**SUBMITTAL TO THE BOARD OF SUPERVISORS
COUNTY OF RIVERSIDE, STATE OF CALIFORNIA**

SUBJECT: TRANSPORTATION AND LAND MANAGEMENT AGENCY/TRANSPORTATION:
Approve Addenda to the Plans and Specifications, Accept the Low Bid and Award the Contract for the Construction of the Clinton Keith Road Construction Project-Phase 3, Leon Road to State Route 79 including the French Valley Creek Bridge in the City of Murrieta and French Valley Area; and the Max Gilliss Blvd and Leon Road Resurfacing Project, Max Gilliss Blvd: Leon Road to Winchester Road, and Leon Road: Clinton Keith Road to Baxter/Jean Nicholas Road in the Community of French Valley, District 3. [\$23,659,634 Total Cost - Local Funds 100%] (Companion Item to MT No. 17919)

Addendum No. 2
Clinton Keith Rd Construction Project – Phase 3
Leon Rd to State Route 79 Including
French Valley Creek Bridge
In the City of Murrieta and French Valley Area
Project No. B2-04723

and;
Max Gilliss Blvd and Leon Rd Resurfacing Project
Max Gilliss Blvd: Leon Rd to Winchester Rd
Leon Rd: Clinton Keith Rd to Baxter/Jean Nicholas Rd
Community of French Valley
Project No. D1-0054

SHEET NO. **D-1**
 OF 25 = 108

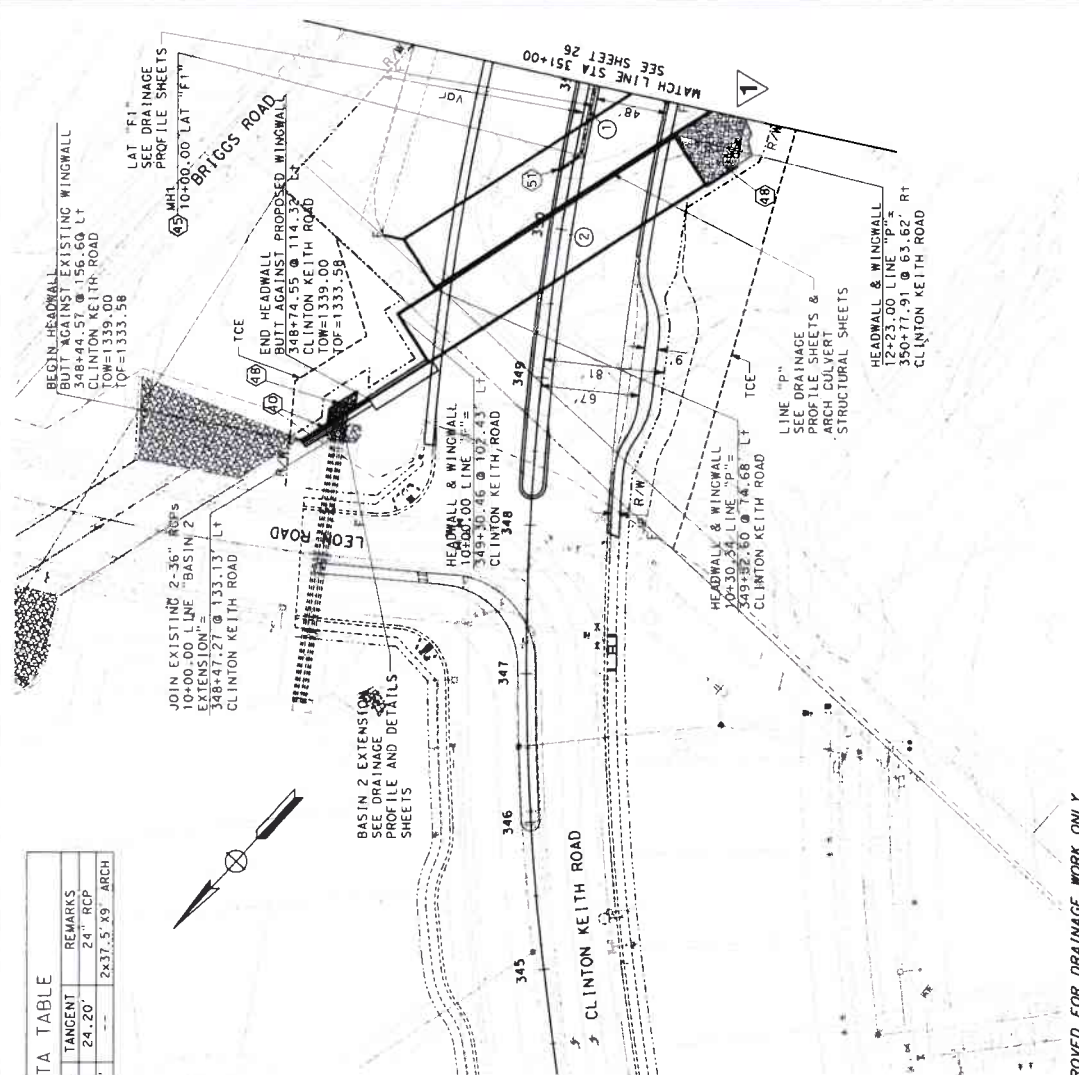
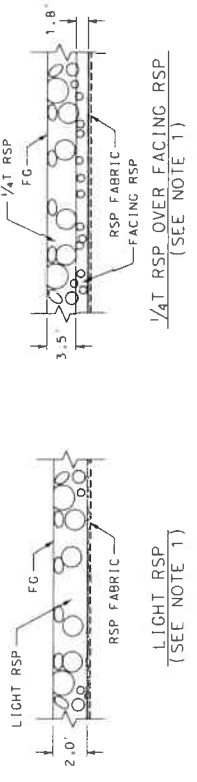
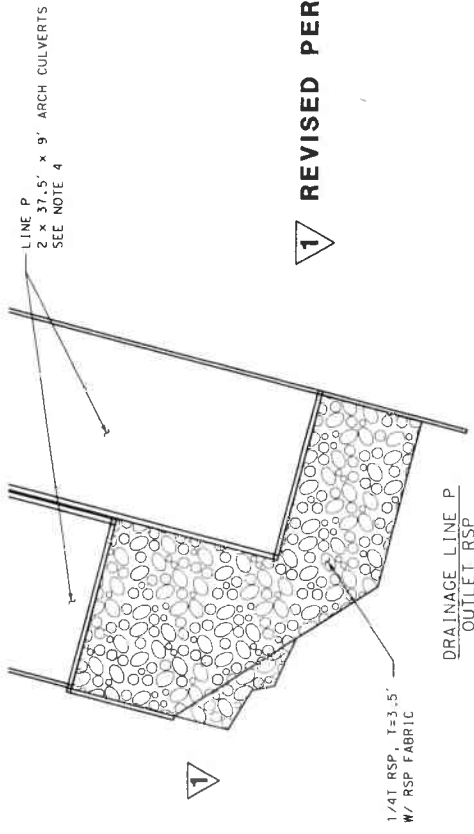
1 REVISED PER ADDENDUM No. 1 DATED OCTOBER 2021

SHEET No.
D-9
 SHEET 33 OF 108

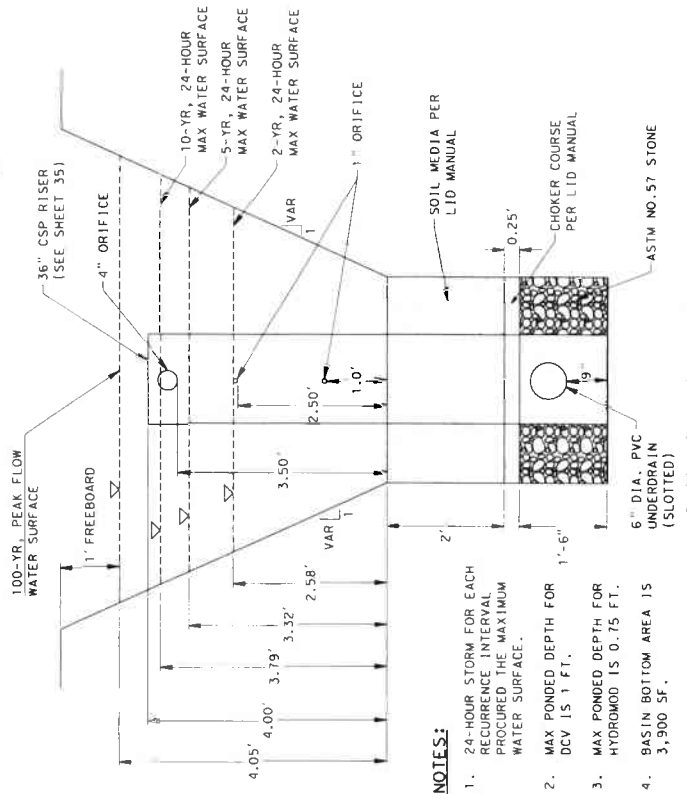
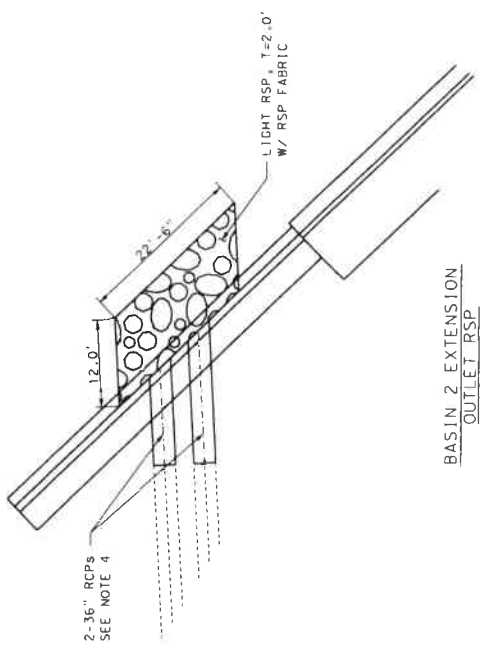
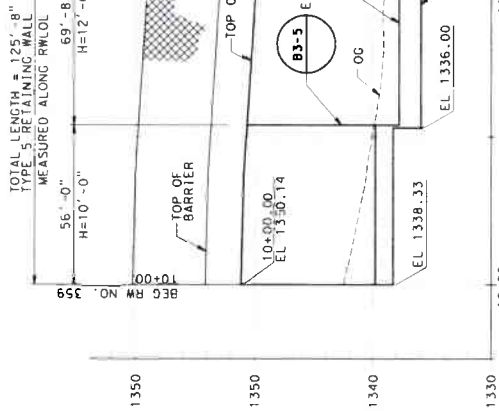
1 REVISED PER ADDENDUM No. 1 DATED OCTOBER 2021

R-3
SHEET 62 OF 108

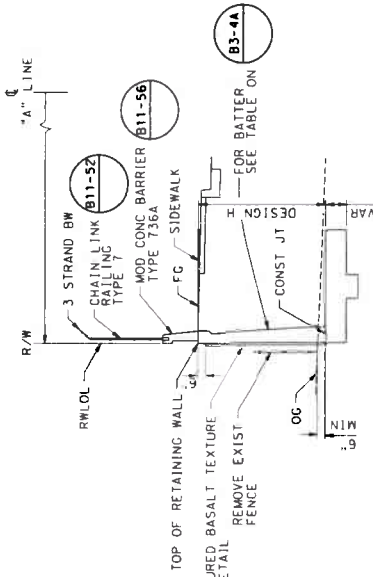
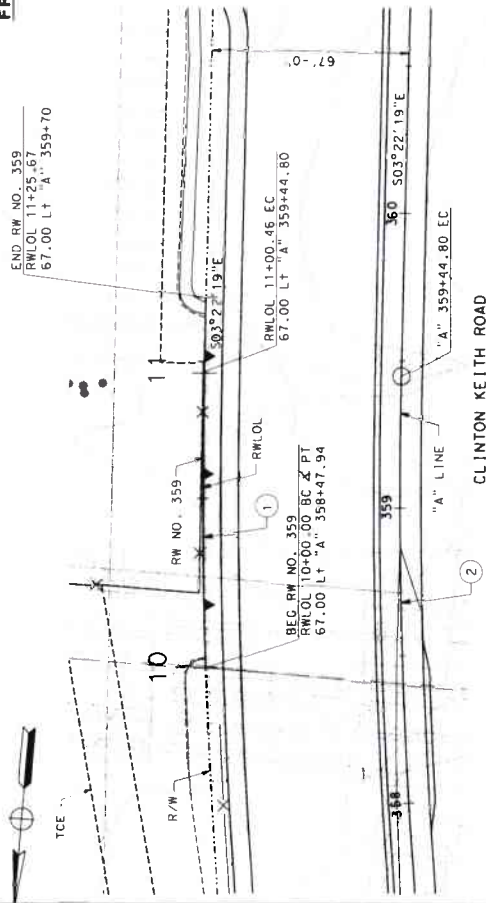
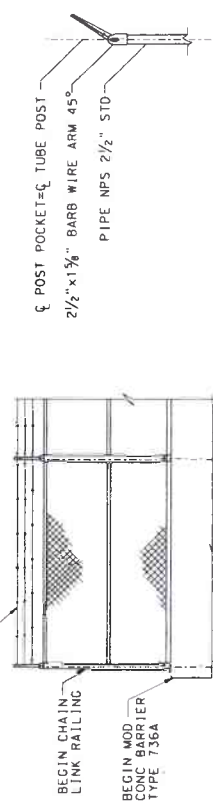
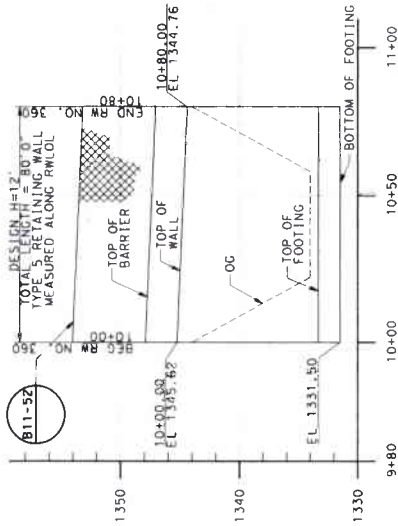
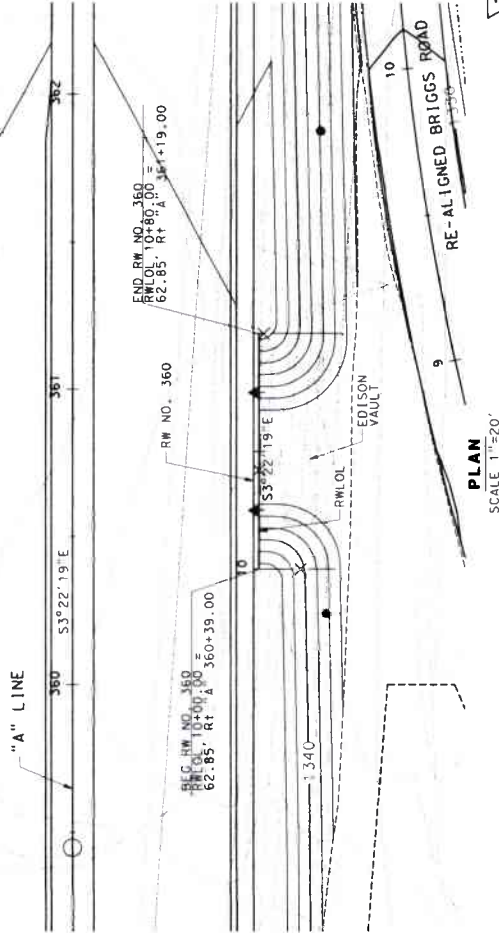
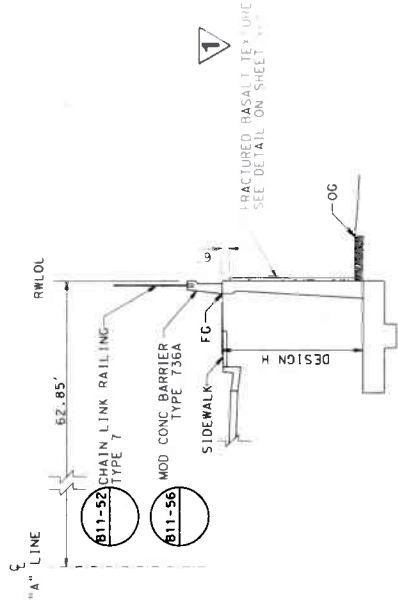
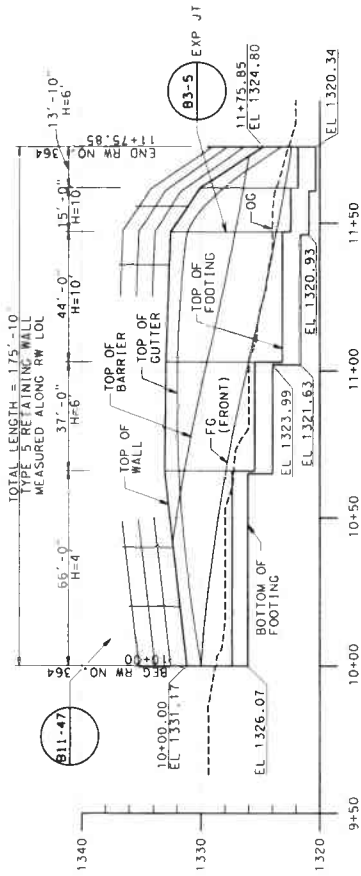
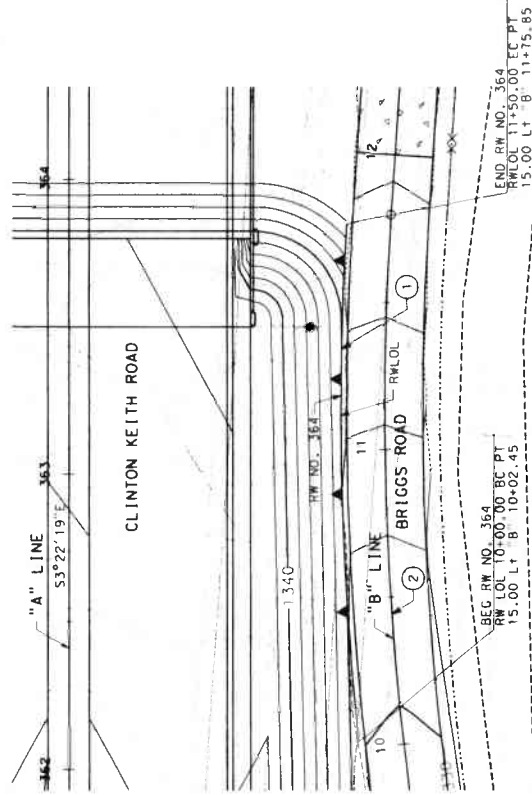
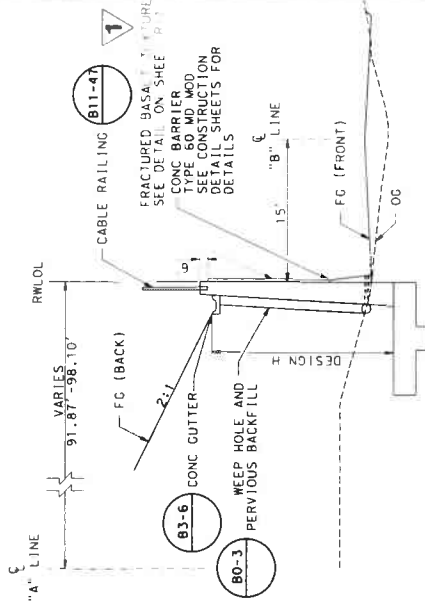
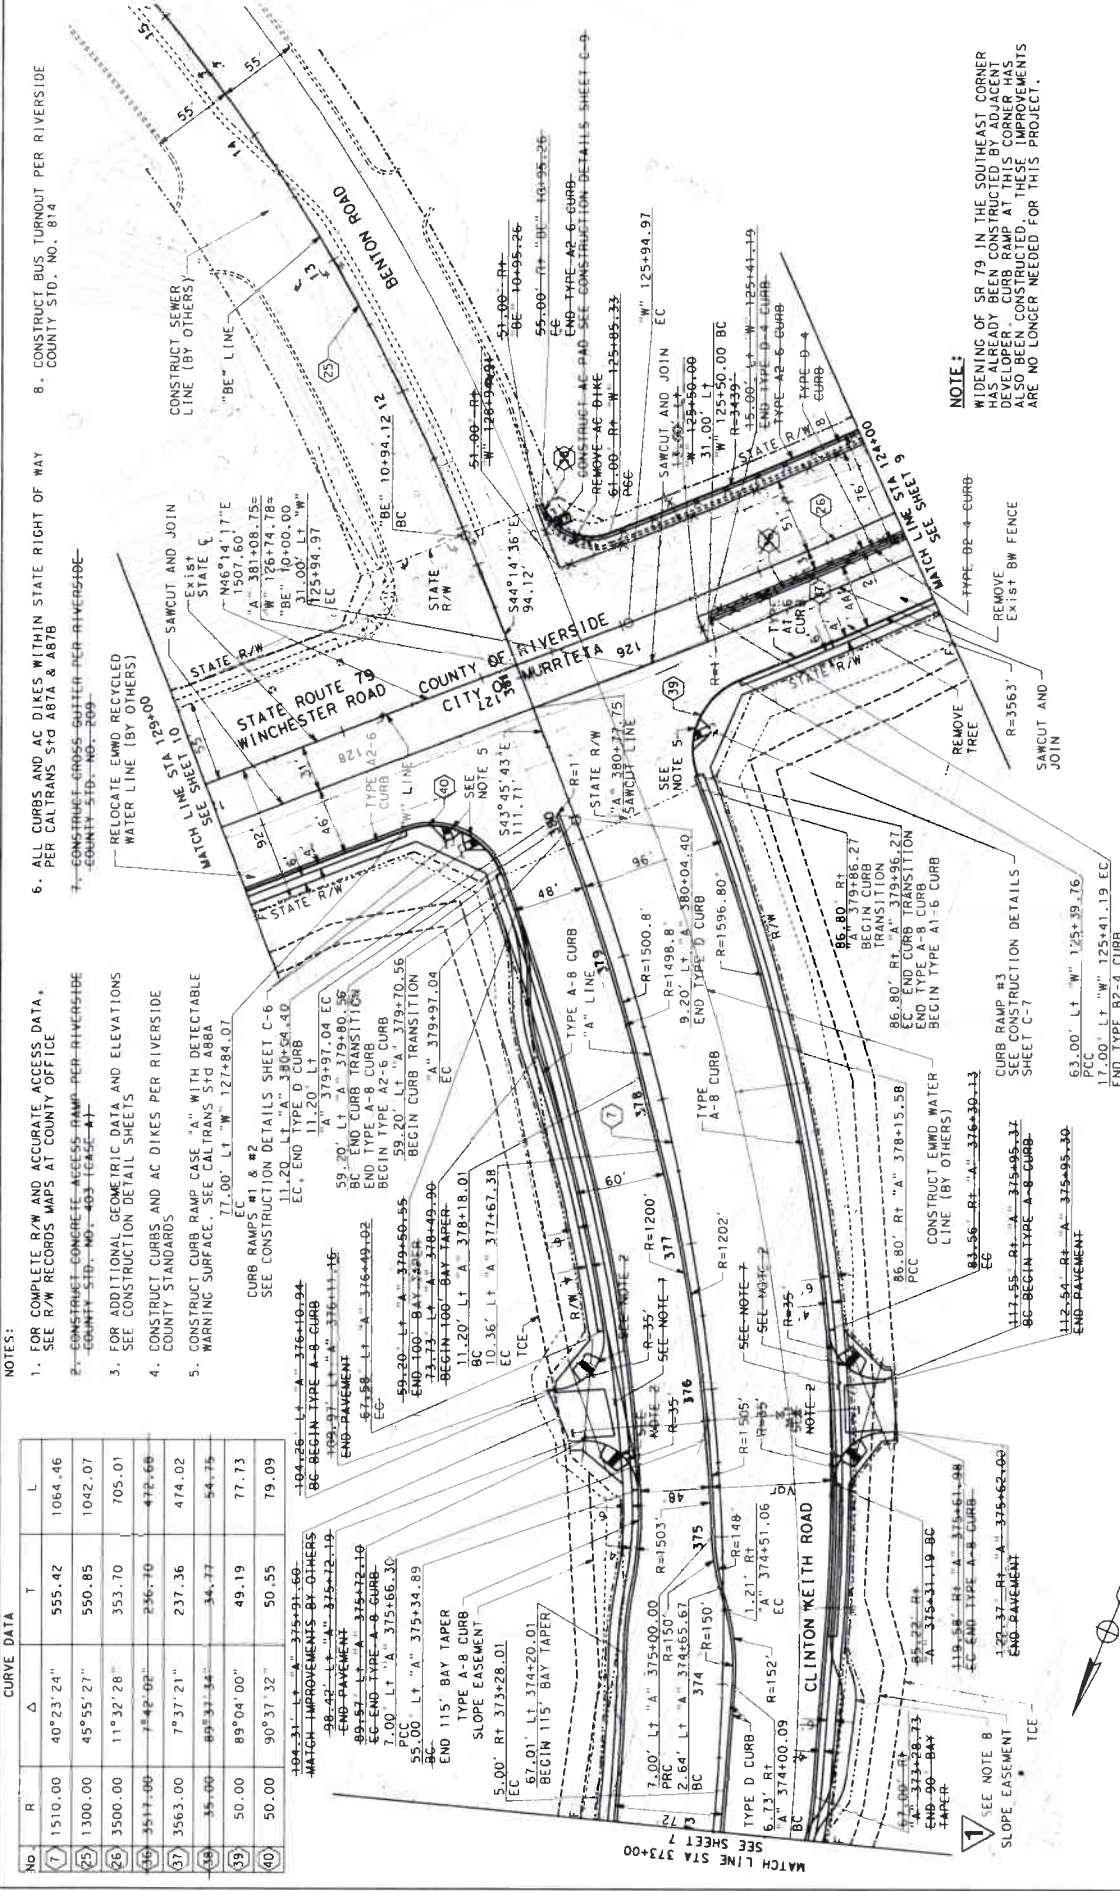
Response	This is the concrete gutter on RW 364, quantity has been revised to 8 cy.
47	Question	Please reference Sheet D-3 (M.M. - 35 of 72), Storm Drain Data Table indicates that three (4, 5, 6) storm drain sections are to be constructed. The plan sheet has no call outs for these pipe runs on the layout (reference circle #). Please clarify if this scope was removed.

1 REVISED PER ADDENDUM NO. 1 DATED OCTOBER 2021

1 REVISED PER ADDENDUM No. 1 DATED OCTOBER 2021

SHEET NO.
D-2
 OF 80
 SHEET 34 OF 80

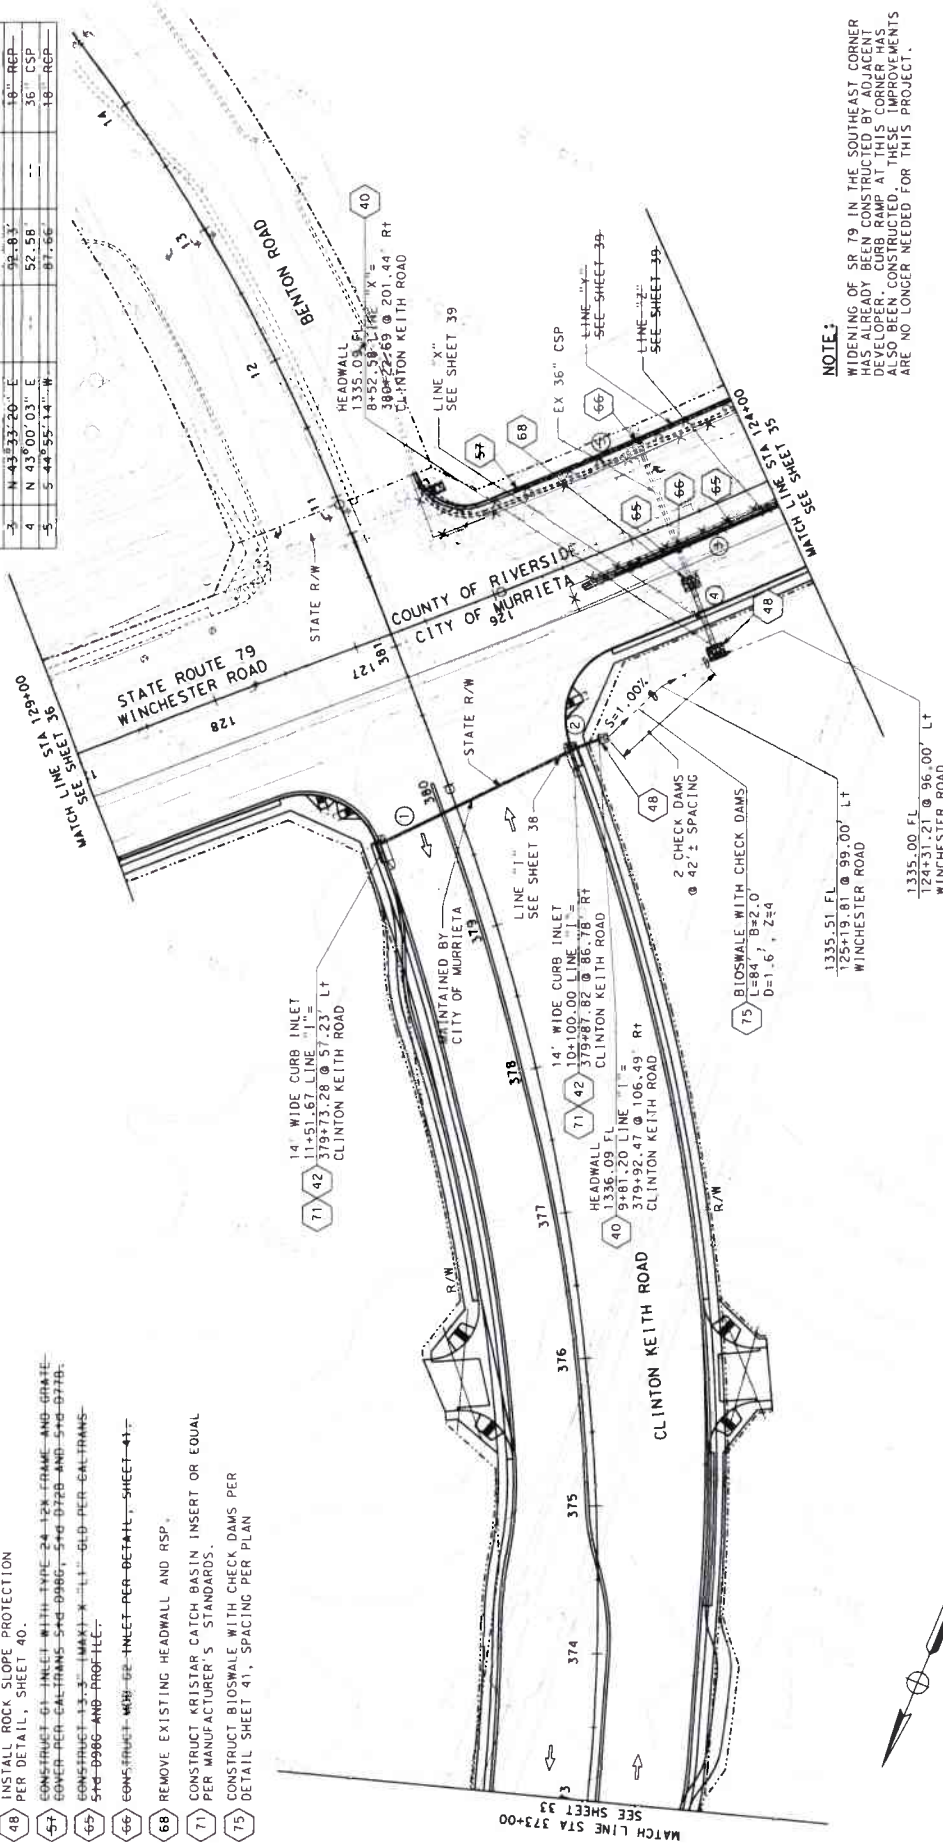
Response	There are no manholes, Bid Item 173 has been deleted.
14	Question	Reference Murrieta Marketplace plan sheets D-2 and DP-3. The plan view for Drainage Line X shows the two Drop Inlets redlined but in the profile view, they are still shown to be constructed. Please advise. If they are part of the work, where will they be paid?

1 REVISED PER ADDENDUM No. 1
DATED OCTOBER 2021
